**Loreto Kirribilli
Innovation Centre**
SSD Modification (s4.55)

Project Name		Loreto Kirribilli - Concept Master Plan and Stage 1	
Project Code		LKIC	
Document Name		SSD Modification Report (s4.55)	
Document ID		190715 Modification Report	
Revision	Date	Comment	Approved
00	04.06.2019	Draft for Information	EC
01	17.06.2019	Draft for Information	EC
02	27.06.2019	Final Draft	EC
03	12.07.2019	Response to Request for Additional Information	EC

1.0 Response to Request for Additional Information

Innovation Centre elevation -
Diagrammatic. NTS

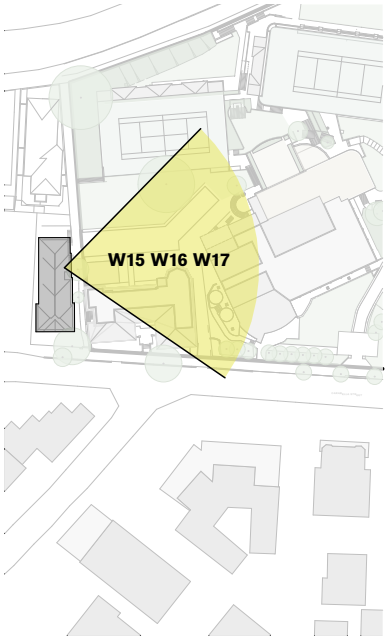
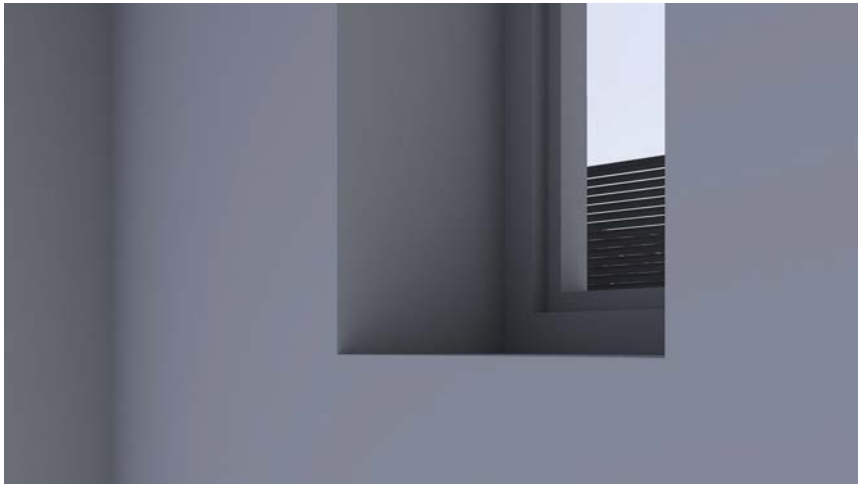
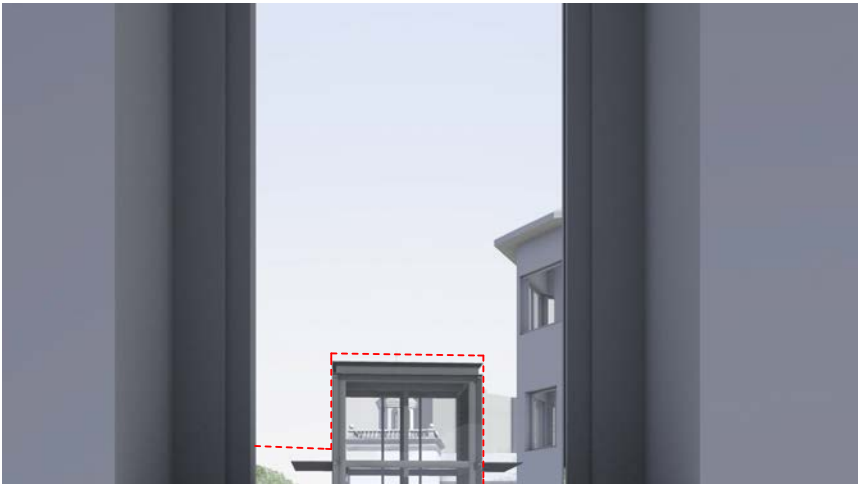
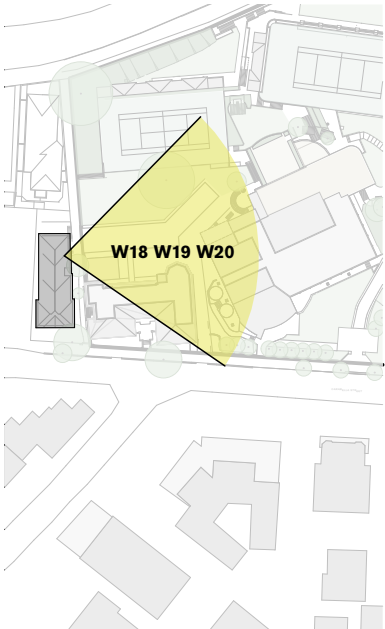
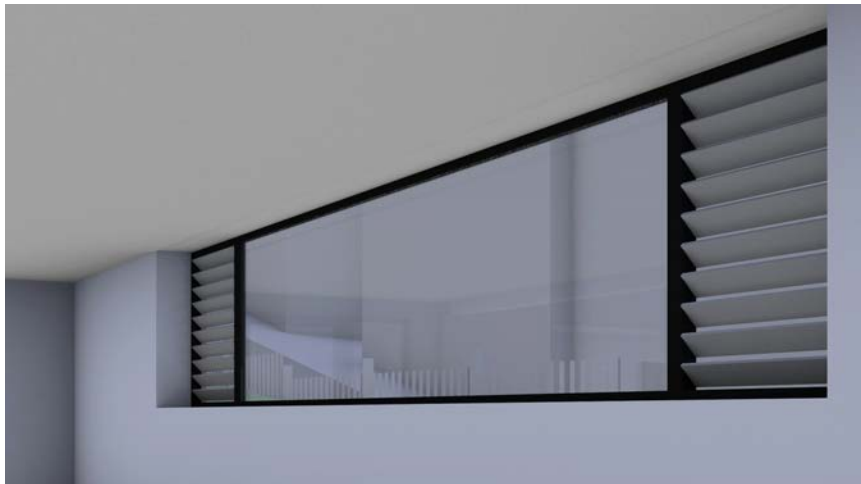
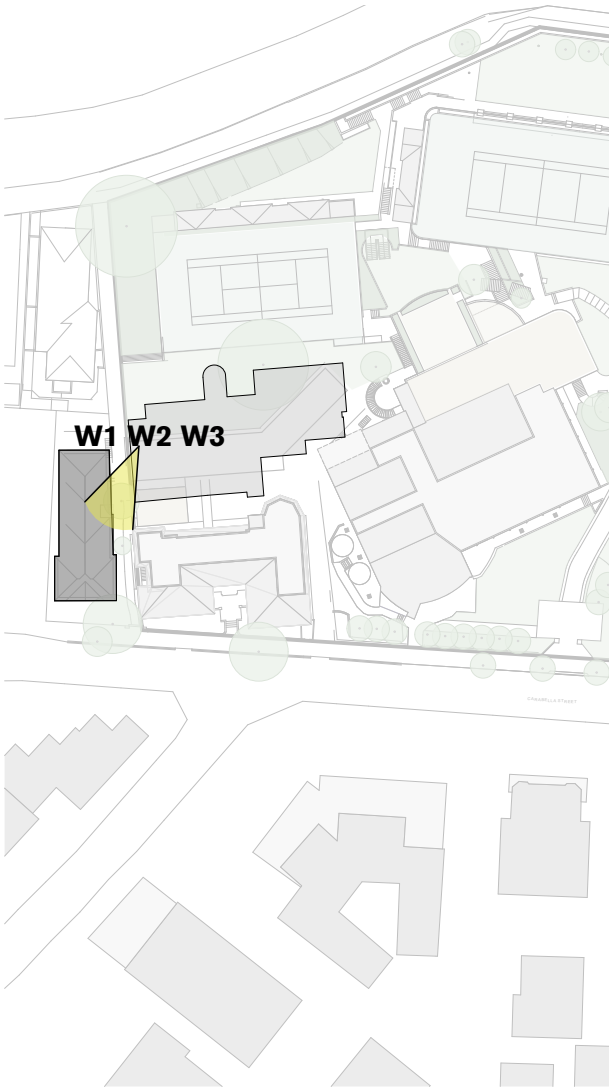
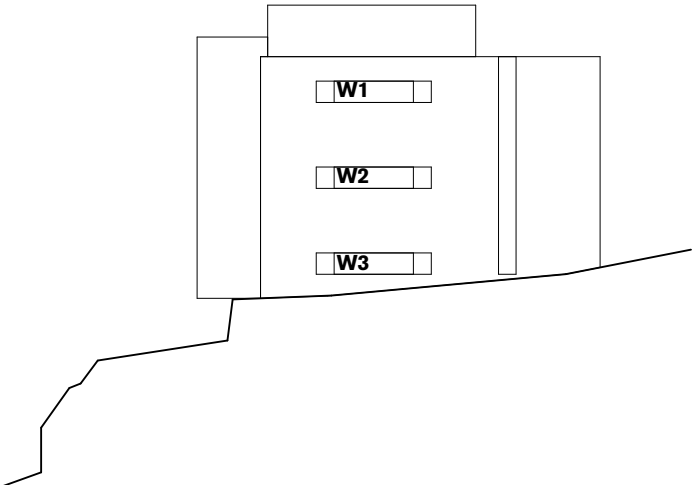
Requested Information from DPIE		Response
10	The submitted western elevation for the innovation centre indicates that the sizes of the window openings have been increased. Additionally, a number of these windows would now be part of the learning studios / studio workshop areas, whereas previously these areas were used for storage (not habitable). Additional sight line diagrams / privacy analysis is required to demonstrate that the amendments to the sizes of the windows would not have additional impact on the adjoining neighbours to the west.	<p>Please refer additional sight line diagrams / privacy analysis.</p> <p>Diagrams illustrate 3 view types:</p> <ul style="list-style-type: none"> - Neighbour viewing out perpendicular to the window - Neighbour viewing out obliquely to window - LKIC building occupant viewing out obliquely towards neighbouring windows <p>In all view types, the diagrams demonstrate views between neighbours and LKIC are mostly obscured by solid walls.</p>

Item 13 Supporting Information
Turning Circle Enter

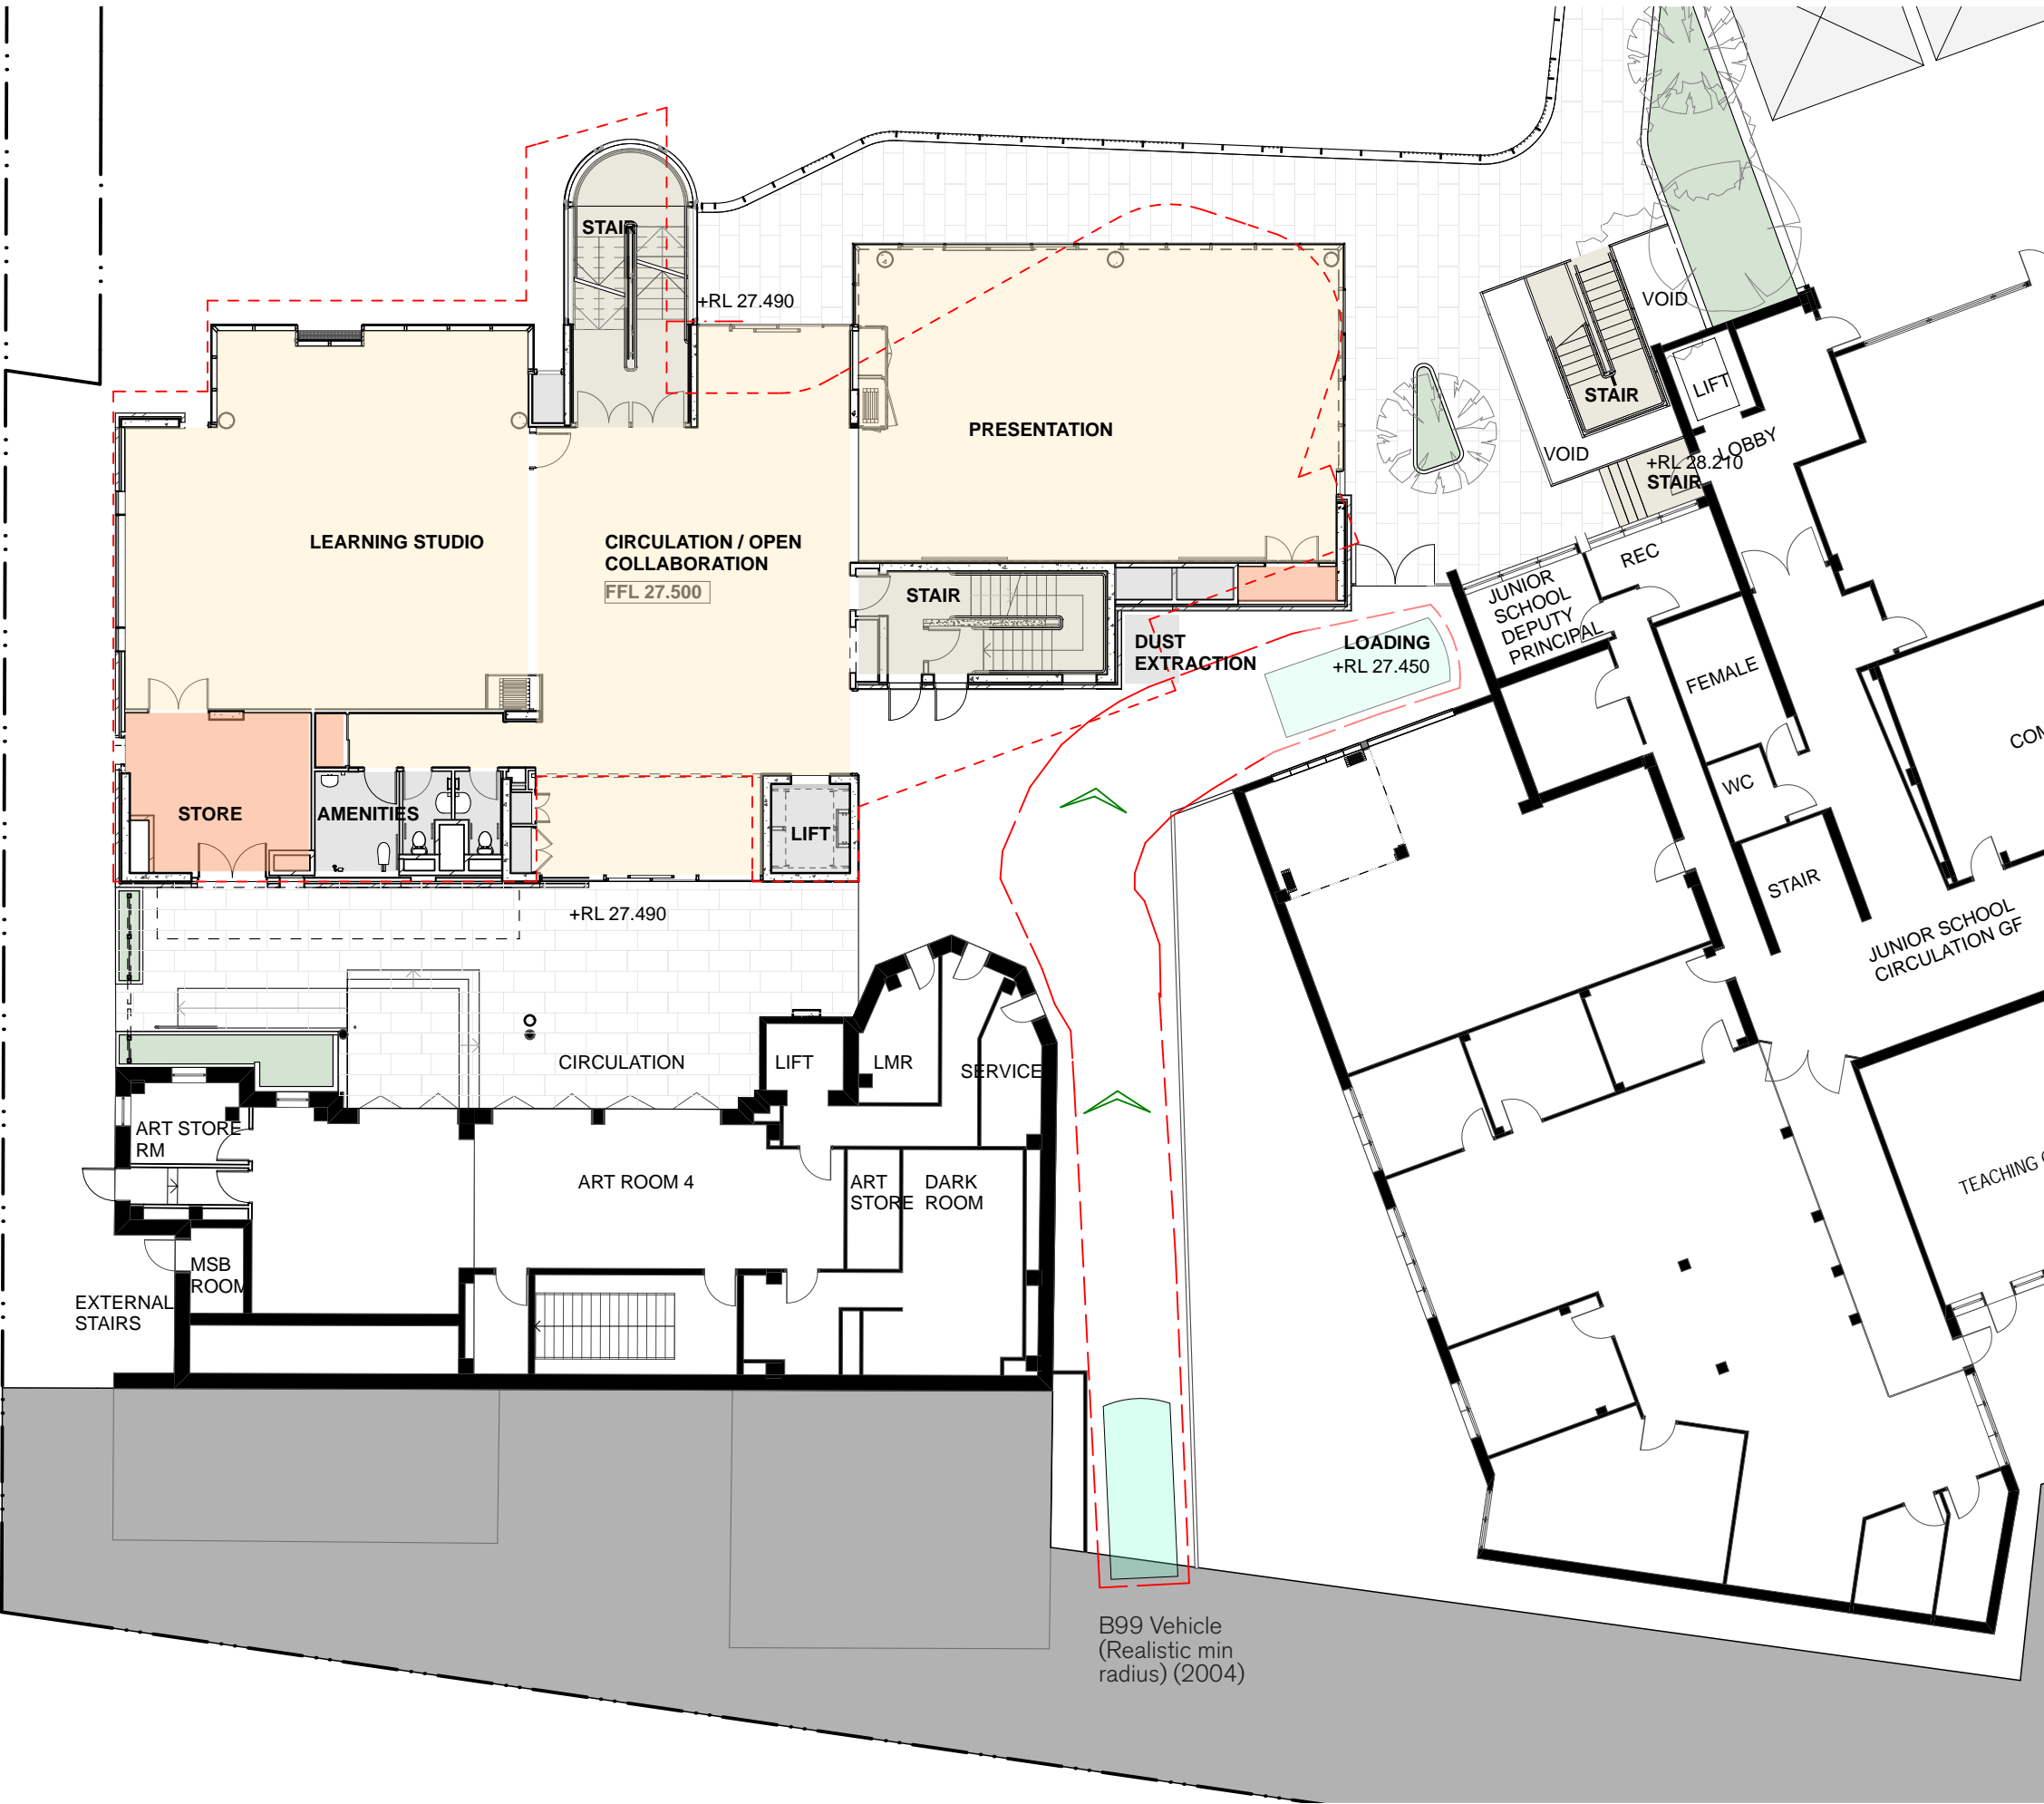
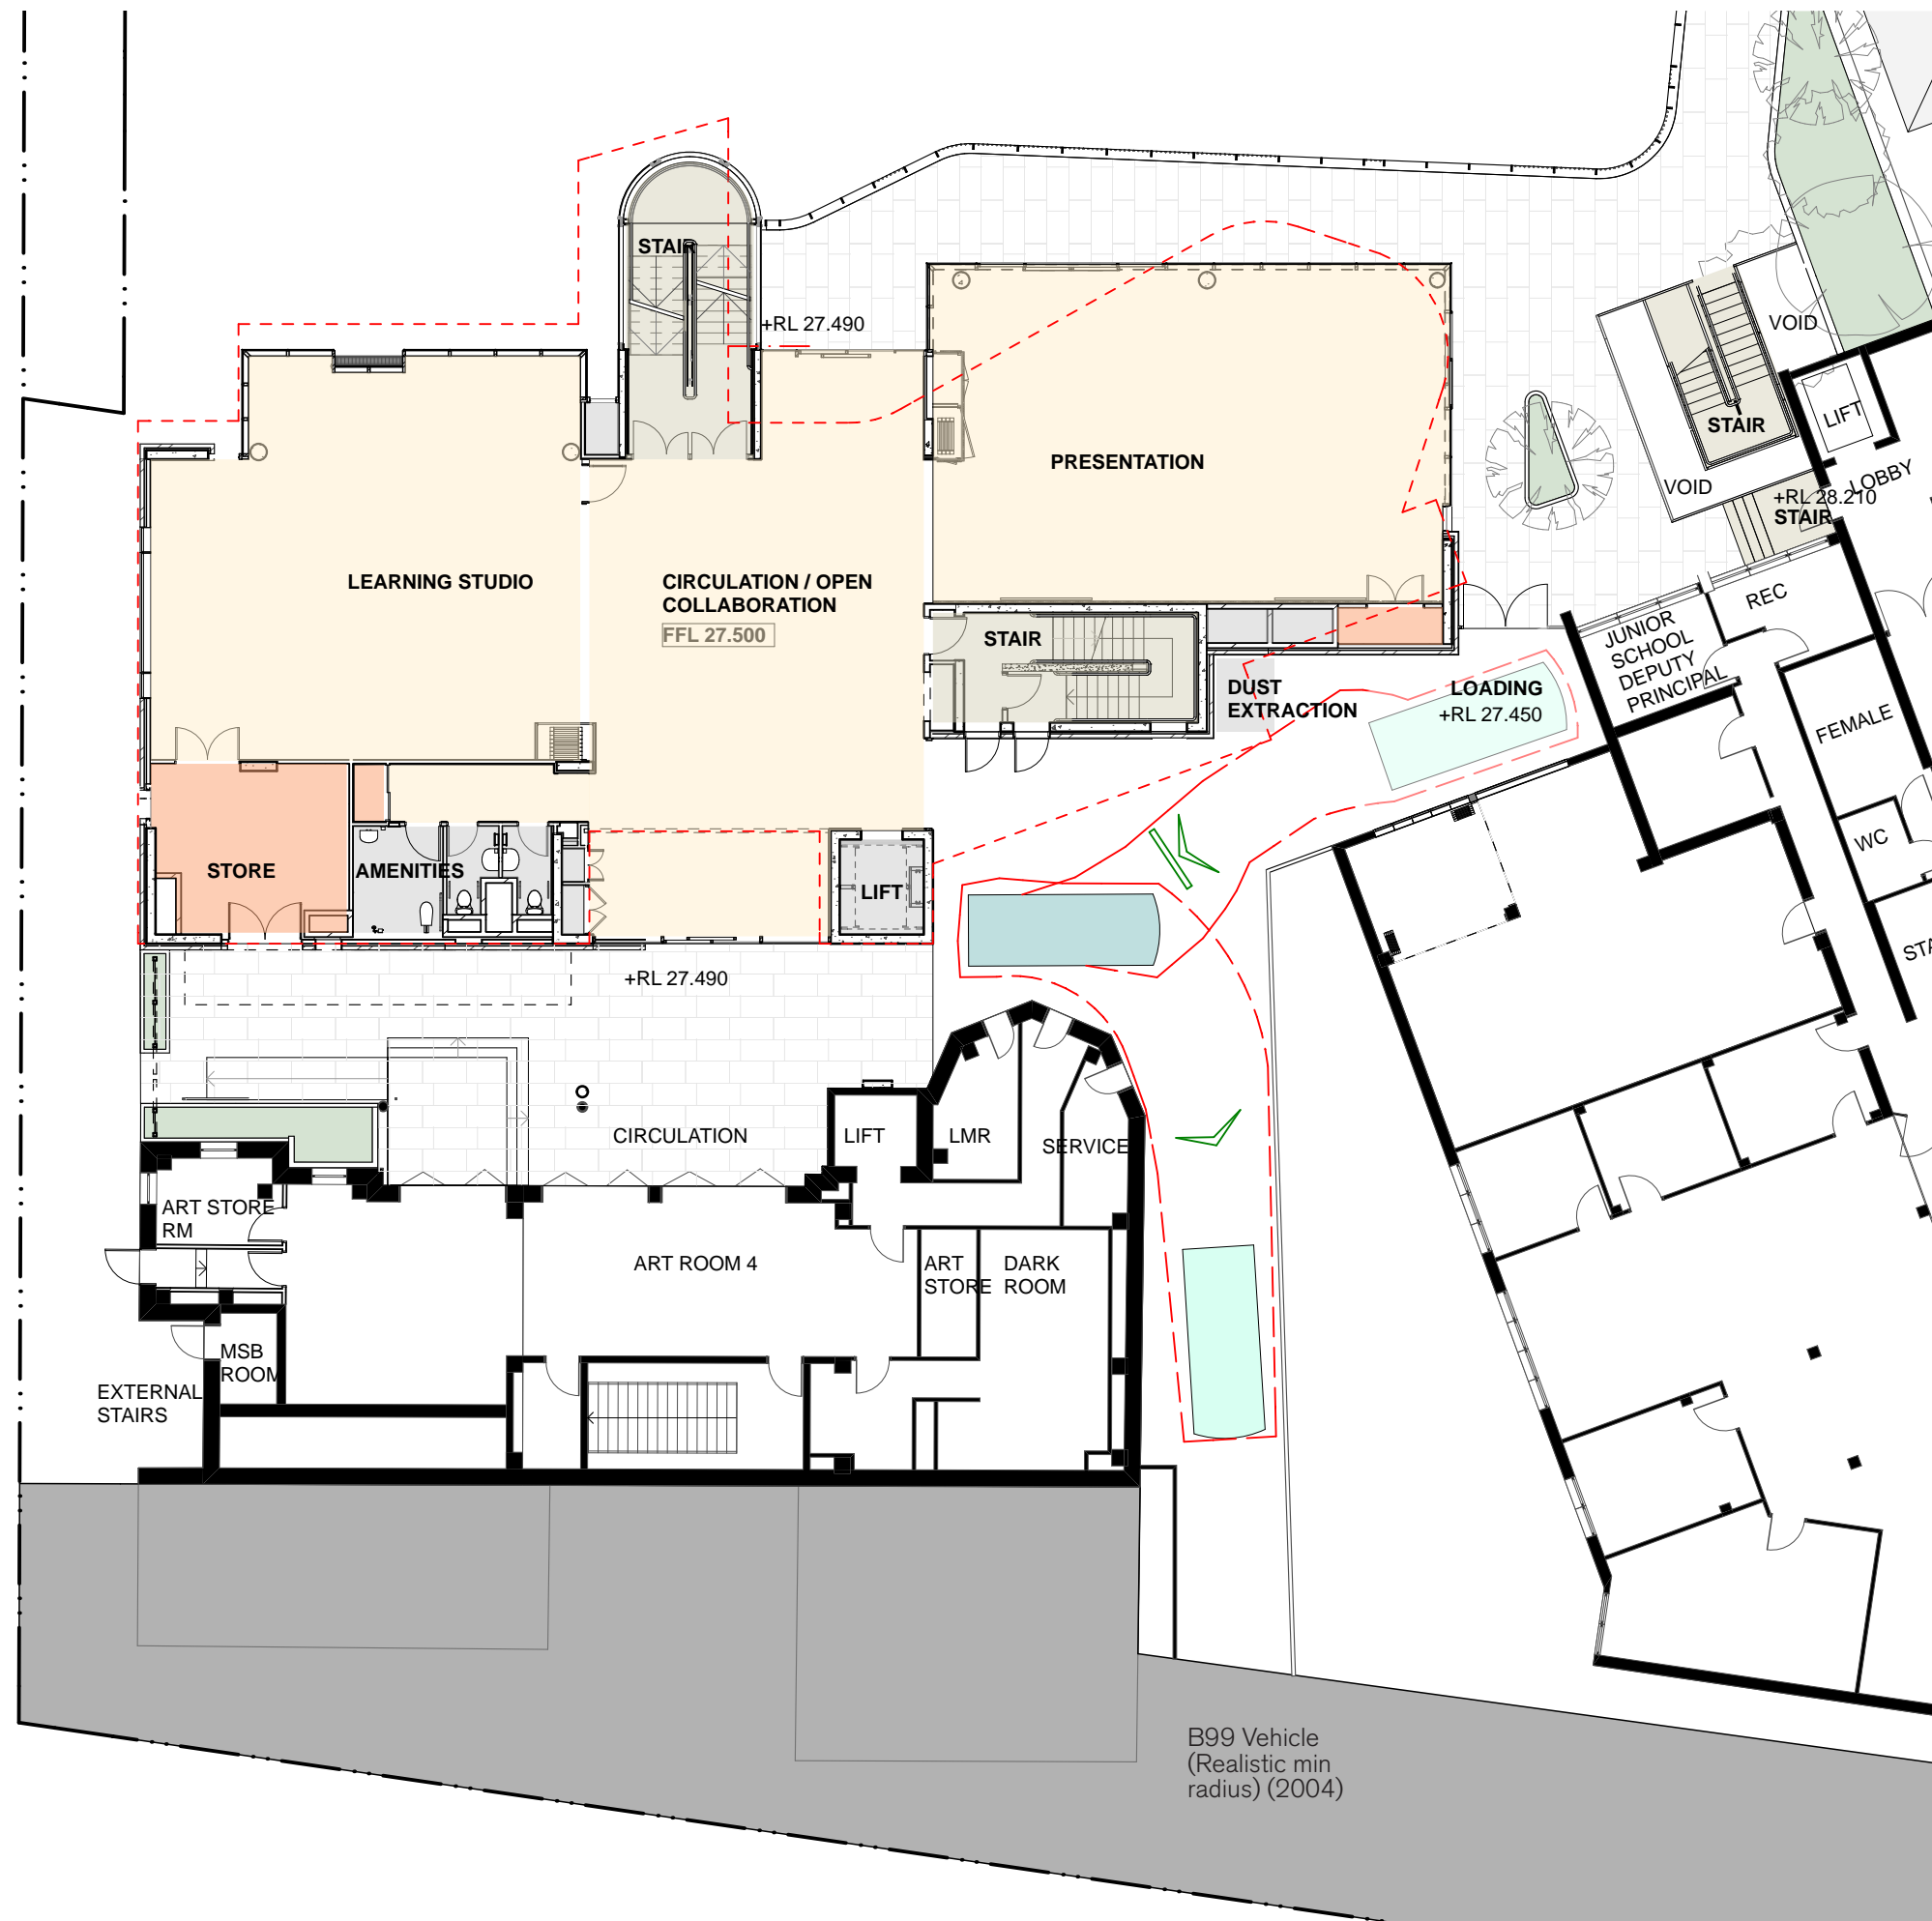
13	A loading area was identified in the previously approved 'Ground Level Plan DA-2205'. This loading area has been excluded from the amended plan. Please include this loading area and identity whether truck manoeuvring is impacted by the proposed reorientation of the building envelope (swept path diagrams may be needed).	<p>Please refer revised Floor Plans.</p> <p>Original vehicle manoeuvring is not impacted by the proposed reorientation of the building envelope.</p>
14	The staff room in DA-2206 includes one window opposite the east facing windows for the units at No. 111 Carabella Street. Previously this was a window for a circulation area (occasional use). However, this window, as modified, would be frequently used by the staff members. Additional information is required to clarify the location of this window and any additional privacy impacts on the neighbours (sightlines may be needed).	Window panel in the Level 1 staff room is solid therefore staff will not be able to view out from the window. It is only used to provide ventilation if required due to the mechanical system shut down .
